Jekyll Island Environmental Assessment Procedure (EAP):

Report summarizing the findings of the EAP Committee considering the condo development concept proposed for Jekyll Harbor Marina, known as "The Moorings".

Date of EAP Committee meeting: 03/04/2019

2nd Report summarizing the findings of the EAP Committee considering the condo development concept proposed for Jekyll Harbor Marina, known as "The Moorings"

Figure 2. This map shows elevations on the JHM leased parcel that fall below 5.96 ft. (Red) and above 5.96 ft. (Green). The elevation data used to generate this map is from 2009.

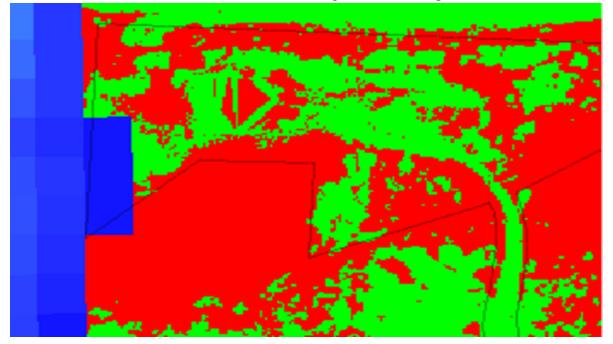
• The property has been observed during recent spring tide events, coinciding with northeasterly wind flow, to be on the cusp of tidal flooding. This means that relatively small increases in water level, due to storm surge, tidal anomalies, or longer term sealevel rise, have a clear potential to flood areas of the property proposed for development. The Committee was not satisfied with the depth of the development team's previous response, dated November 8, 2018, to JIA on the question of sea level rise. Furthermore, the committee emphasized that, although the language in the Jekyll Island Master Plan calling for new projects to plan for between 1.3 and 2.3 feet of sea level rise by 2060, is an important policy, the importance of flood resiliency is immediate and not just an issue of the distant future.

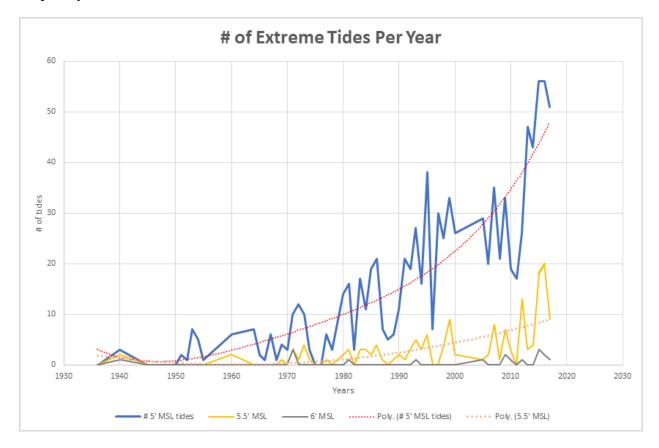
Figure 3. This Graph shows the frequency per year of tide levels of different heights above mean sea level (MSL) and associated historic trend lines. These data are from actual measurements at Fort Pulaski, Georgia, not computer-model projections. Number of tides is on the vertical axis and year is on the horizontal axis. The blue line shows the number times in each year that a high tide exceeded 5-feet above MSL. The yellow line shows the same for 5.5-feet, and the black line for 6-feet. The trend lines show that the rate of increase in the frequency that these "extreme" high tides are occuring has been increasing exponentially since around 1950. This means that a tide event such as the one shown in Figure 1, or higher, can be expected to occur more and more frequently in the future.

Figure 4. Screen Grab for the NOAA Sea Level Rise Viewer tool. <u>https://coast.noaa.gov/digitalcoast/tools/slr.html</u>

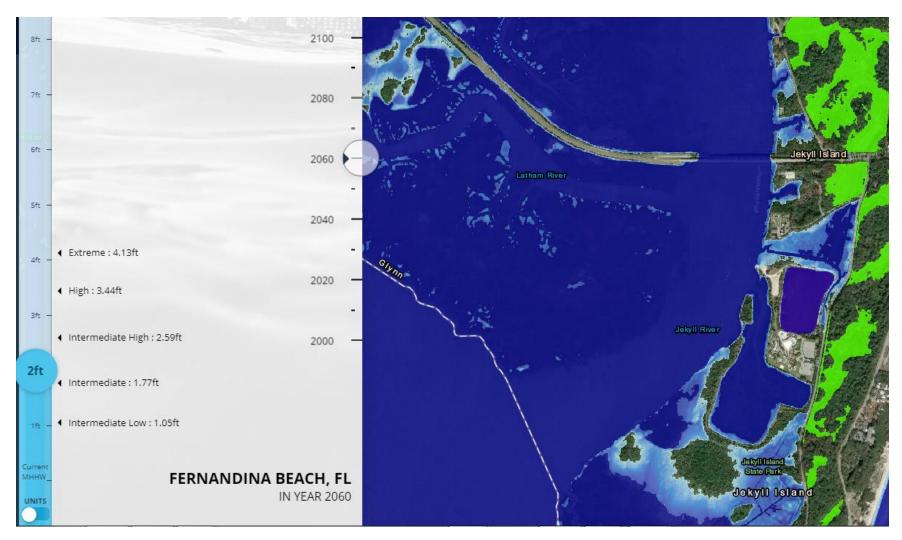
This model-based prediction of sea level shows that for intermediate predictions of the rate of future sea-level rise in our area, calling for about 2-feet of rise by the year 2060, the eastern periphery of the Jekyll Harbor Marina lease could be below Mean Higher High Water (MHHW) - the average daily highest tide.

Figure 4. Screen Grab for the NOAA Sea Level Rise Viewer tool. <u>https://coast.noaa.gov/digitalcoast/tools/slr.html</u>

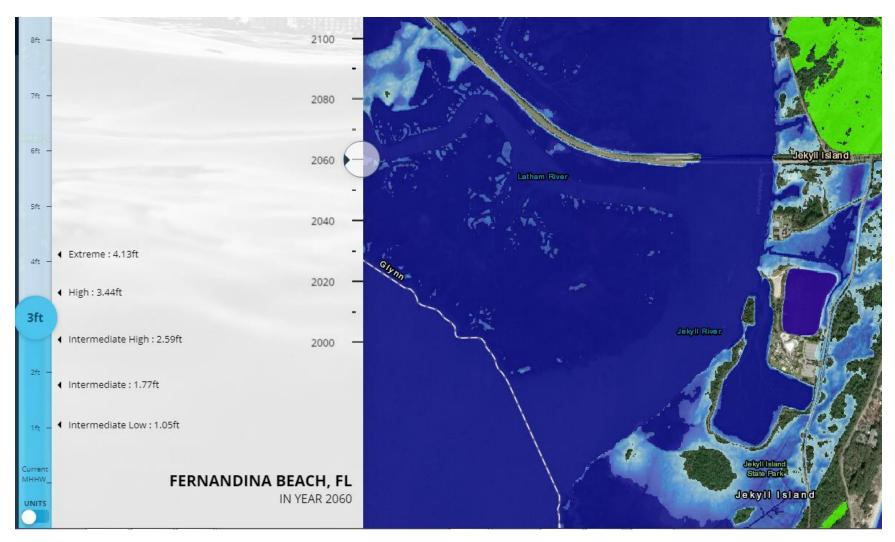
This model-based prediction of sea level shows that for higher predictions of the rate of future sea-level rise in our area, calling for about 3-feet of rise by the year 2060, or for more moderate predictions further out in time, a substantial percentage of the Jekyll Harbor Marina lease could be below Mean Higher High Water (MHHW) - the average daily highest tide.
